SUBJECT LAND: 298-300 Brunswick Street, Fitzroy

Attachment 2 - 990390.02 - 298-300 Brunswick Street, Fitzroy - Advertised plans

Project
Roof top bar

SLR Consulting Australia Pty Ltd (SLR) has been retained by the City of Yarra to provide a review of the acoustic assessment report prepared to support the application for a changes to the bar at 298-300 Brunswick Street, Fitzroy.

Drawing Title
 PROPOSED ROOFTOP
 RED LINE PLAN

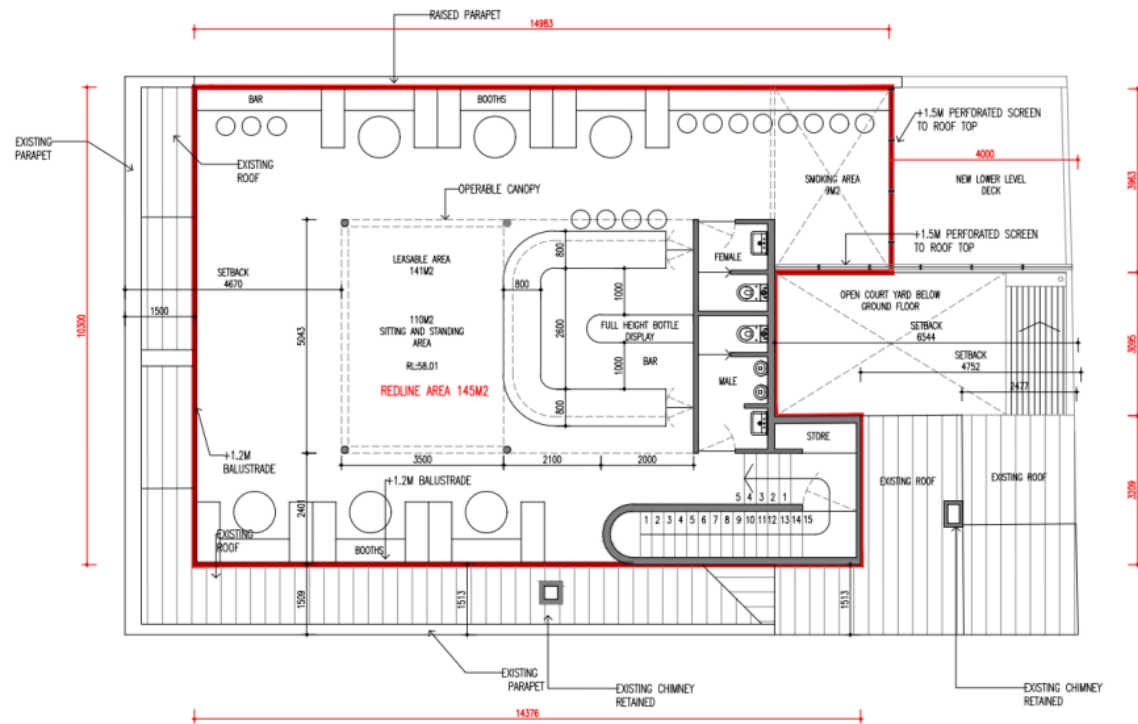
- It is recommended that the red line plan be amended to ensure it does not include amenities (i.e. toilets).
- Practice Note 61 notes that *Venues that serve food or meals are shown to be less at risk of excessive alcohol consumption. This does not include venues that only serve basic snacks*. The venue acknowledges the importance of a food offering as a measure to reduce alcohol intake and to reduce the risks of harm associated with excessive consumption of alcohol. A food menu that advertises the availability of food, consisting of more than pre-packaged snacks, will be available to patrons at all times alcohol may be consumed. This is supported and is recommended to be retained as a condition of permit.

Above: Extent of existing roof form proposed for removal shaded in red

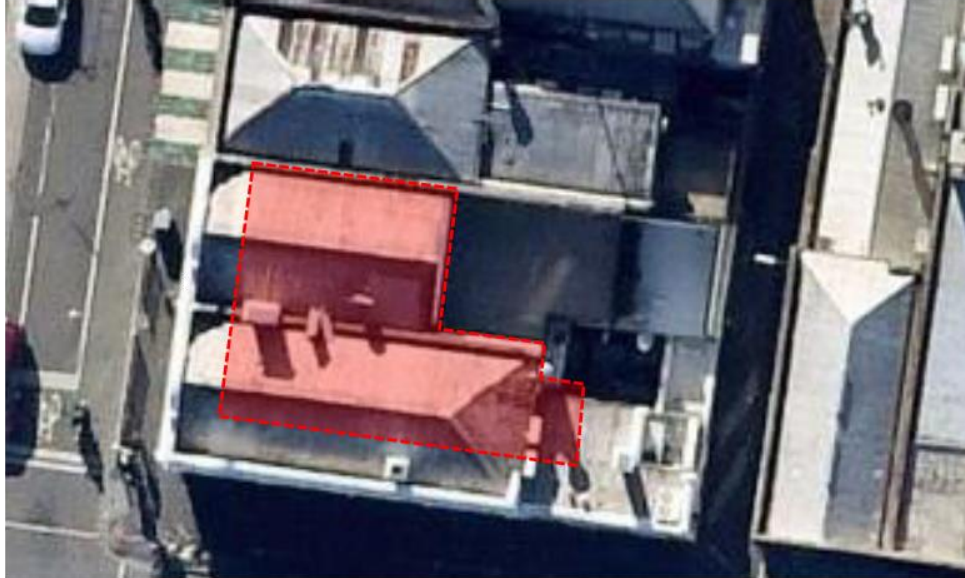
The extent of demolition proposed by this application includes the demolition/removal of most of the original roof form.

In accordance with Clause 22.02-5.1 of the Yarra Planning Scheme the extent of demolition is supported on the grounds that it is not visible from the street frontage. It does not however satisfy the requirement that the main building form including roof form is maintained. It is considered that more of the original roof form needs to be retained. It is considered that the two outside roof pitches should be fully retained for the purposes of maintaining the distant views and the front portion of the roof form should be retained at least to the depth of the rear of the chimney.

Furthermore, the extent of demolition proposed will involve removal of a large chimney that is visible from the street. The chimney is a contributory element (CI.22.02-3) and its demolition is not supported (CI.22.02-5.1).

Suggested condition	Explanation
1.	That the extent of original roof form to be demolished must be reduced	<i>The main building roof form is not being maintained</i>

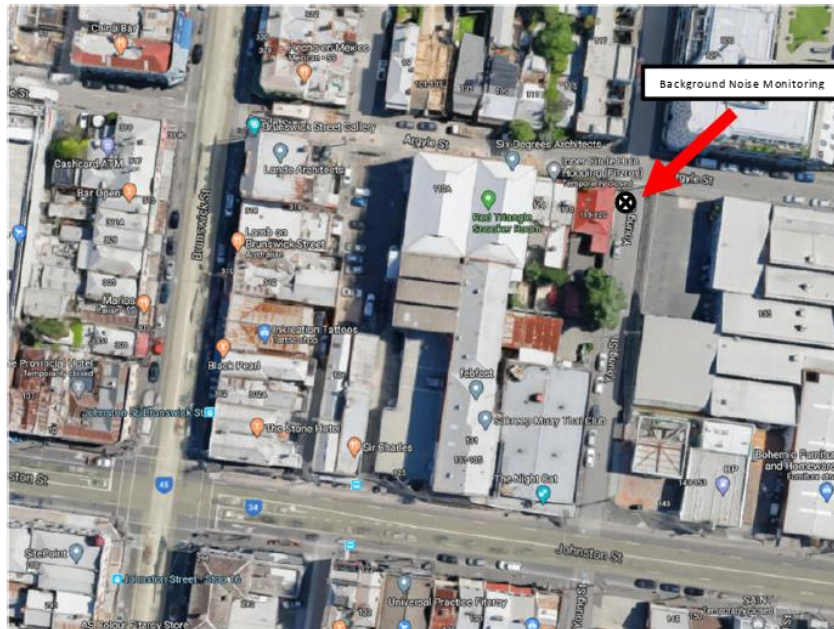
SLR Comments: The use of a derived point for measuring background noise is reasonable however the report should include details of where the derived point is, and the time and day that the measurement/s were undertaken. Without this information is it not possible to provide a technical review of the data.

Background noise monitoring was conducted 30 October between 1am and 1:30am on the corner of Young and Argyle Street. This location was selected to avoid mechanical plant and public noise which is prevalent proximate to the corner of Brunswick and Johnston Streets, and the nearest sensitive receptor.

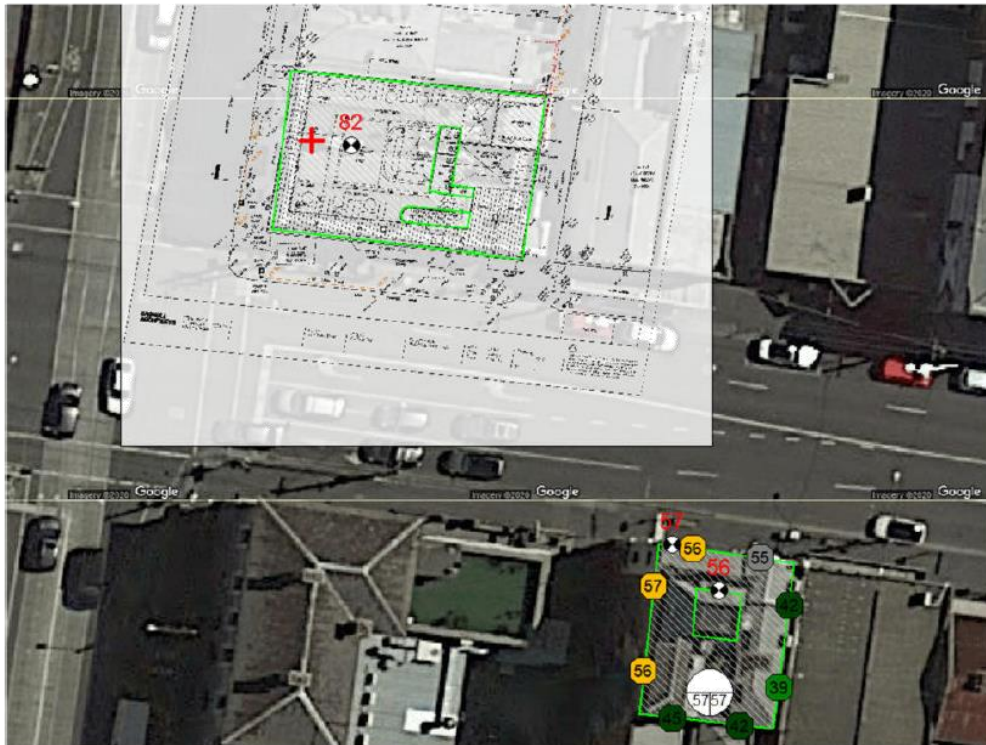
SLR Comments: The proposal, potential noise impacts and the nearest noise sensitive receivers have generally been identified. However, real estate websites suggest that the upper levels of the building at 120 Johnston Street, which is approximately 40 m southeast of the venue, are also residential. While this building is further from the subject site than 306 Brunswick Street, it may have a more direct line of sight to the proposed roof deck.

A review of Google Street View and real estate websites confirms that a multi-level building with residential dwellings from level 1 and above exists on 120 Johnston Street. We note that the 120 Johnston Street is above a licensed venue and also directly opposite another licensed venue which includes an outdoor patron area at the rear of 296 Brunswick Street.

Appendix B: Proposed Bin Room Layout

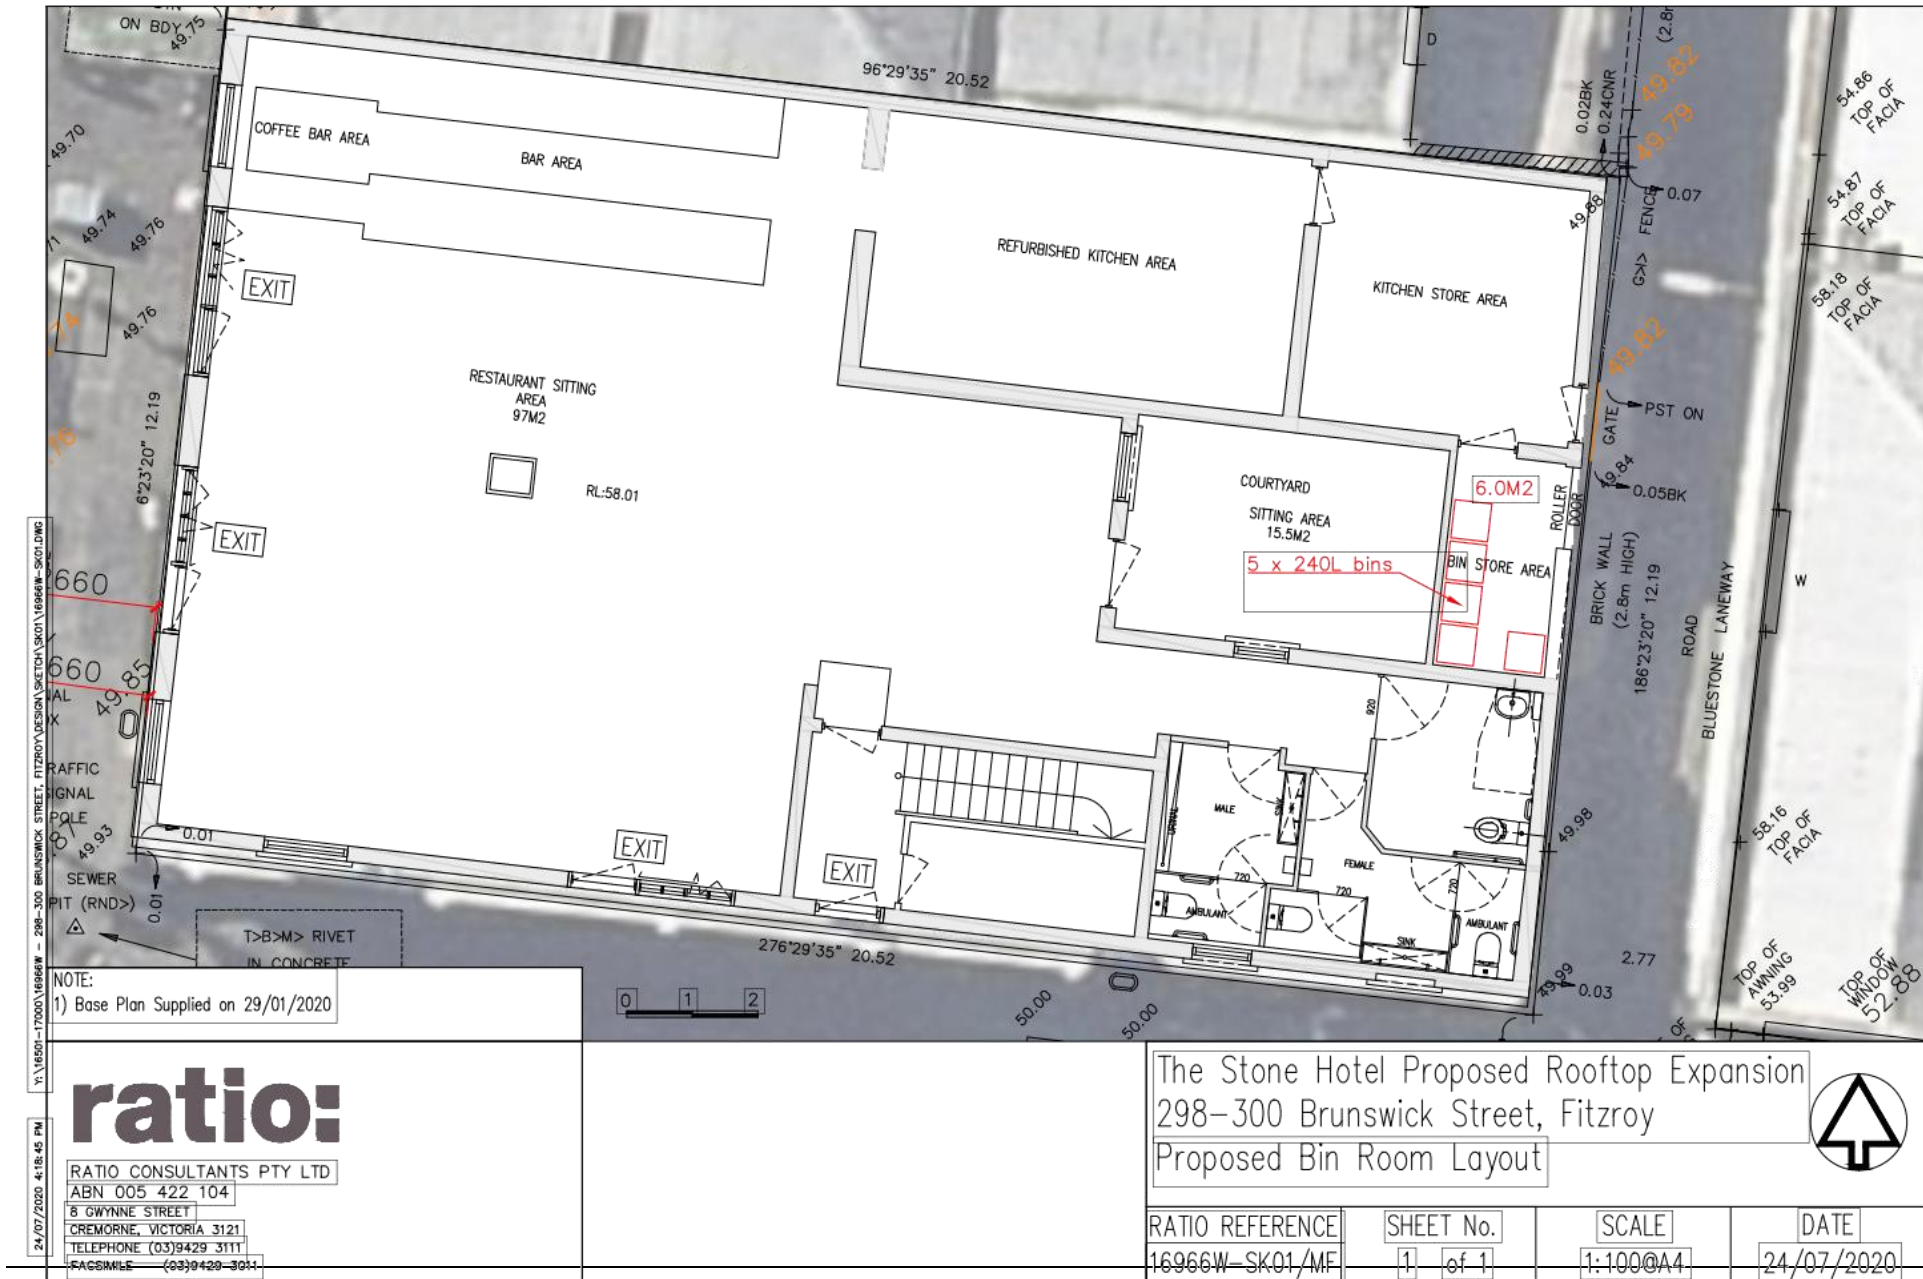
1. *Please provide the total size of the bin storage area by m².*
2. *Food waste diversion should be included as a requirement.*
3. *Please investigate minimising proposed collections per stream.*

The area allocated for bin storage shown on the Architectural Plans (6m²) is sufficient to store the required number of bins outlined above. Refer to Appendix B for the proposed bin room layout.
